Technical Service Bulletin

Topic	EPB Warning light in DIP - Front door/s power latch system intermittent - DTC U112300 within Address 03 and Address 46
Market area	Bentley: worldwide (2WBE),Hongkong-Macau (5HK)
Brand	Bentley
Transaction No.	2055883/1
Level	EH
Status	Released for publishing
Release date	Sep 5, 2019

Figure 2

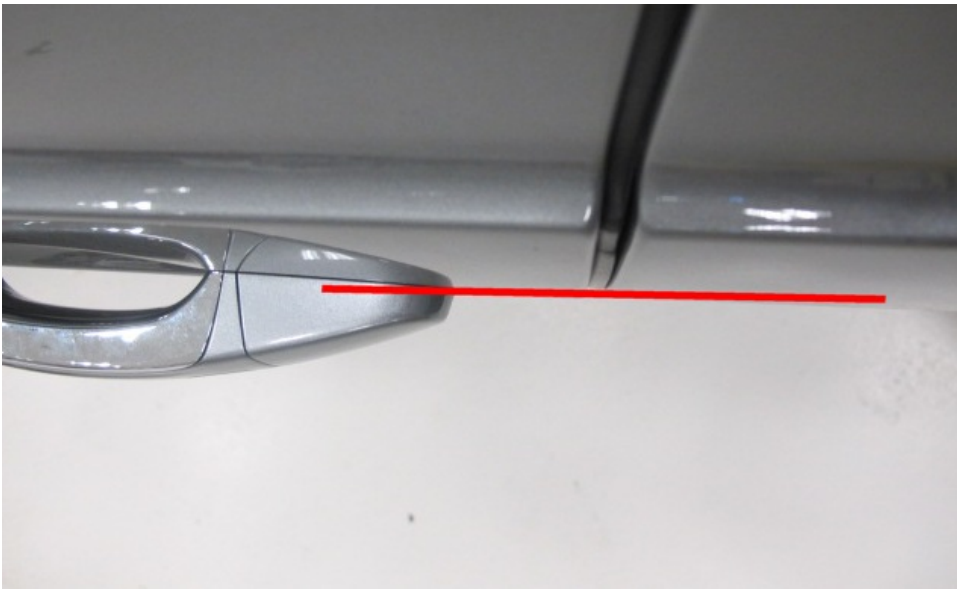
If required adjust the door to the inside so that the front door is flush with the rear door - Refer to Rep.Gr 57. A small gap from front to rear door is possible and will not normally cause wind noises (Figure 2)

Figure 3

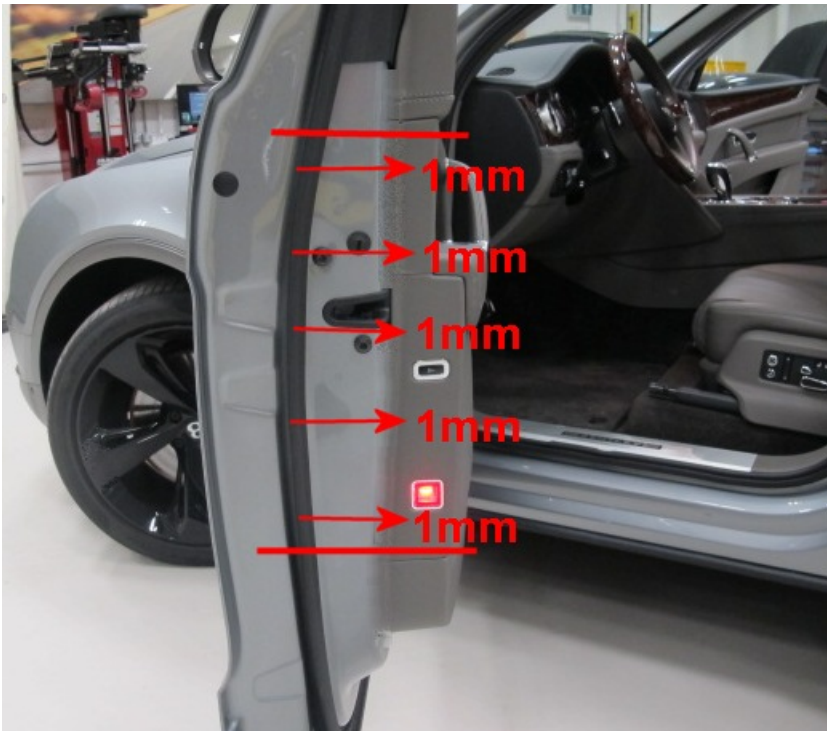
2) In individual cases it may be necessary to replace the outer door seal of the affected door

Then glue the new seal in the area of the door lock about 1 mm further inwards (Figure 3)
